**PREVOST**

**WARRANTY  
BULLETIN**

**WB15-19**

DATE :	JULY 2015	SECTION :	22 - HVAC
EXPIRATION:	JULY 2017		
SUBJECT :	<b>BITZER A/C COMPRESSOR VIBRATION – ADDITION OF A REINFORCEMENT BRACKET TO THE MOUNTING</b>

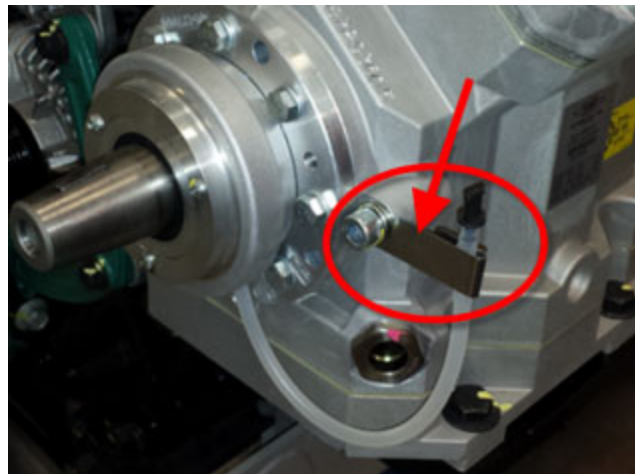
14. Install new reinforcement bracket #457675 as shown using previously removed hardware (bolt (C) and flat washer). DO NOT tighten at this moment.

*Note: Use blue Loctite 243 on threads.*

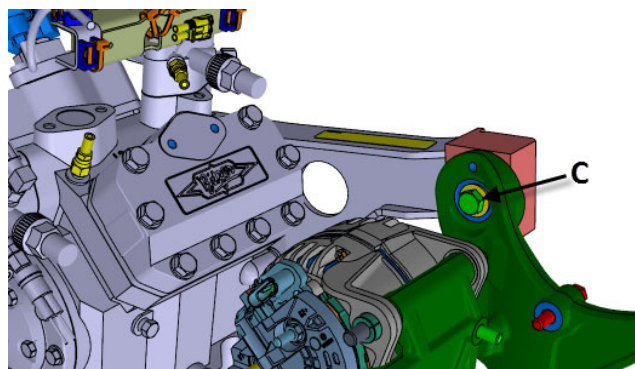
15. Carry on with the installation of new reinforcement bracket #457675 as shown. Use two cap screws #502949 (**E**).

*Note: Use blue Loctite 243 on threads.*

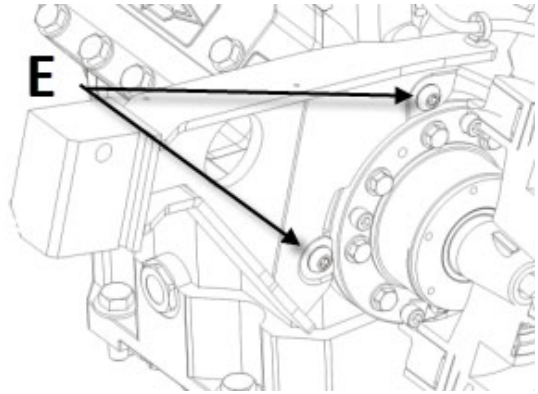
16. Tighten bolts (**E**) and bolt (**C**).

**E**= 32 lbf-ft

**C**= 74 lbf-ft

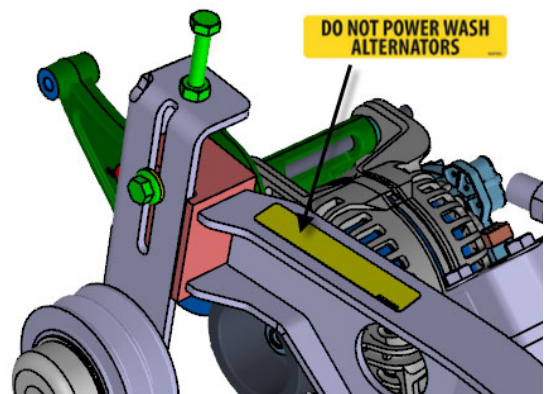
18. Apply decal #069356 were indicated on the image.

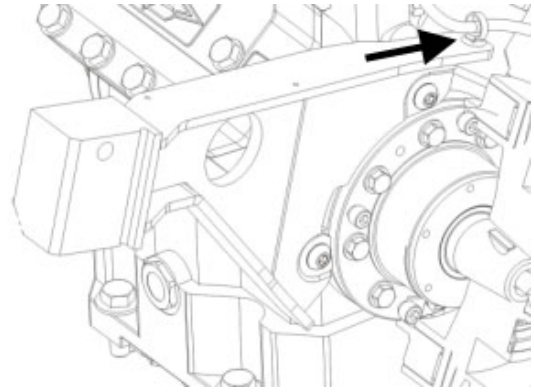
- 
19. Install nylon tie mount #509815 where indicated on the image.
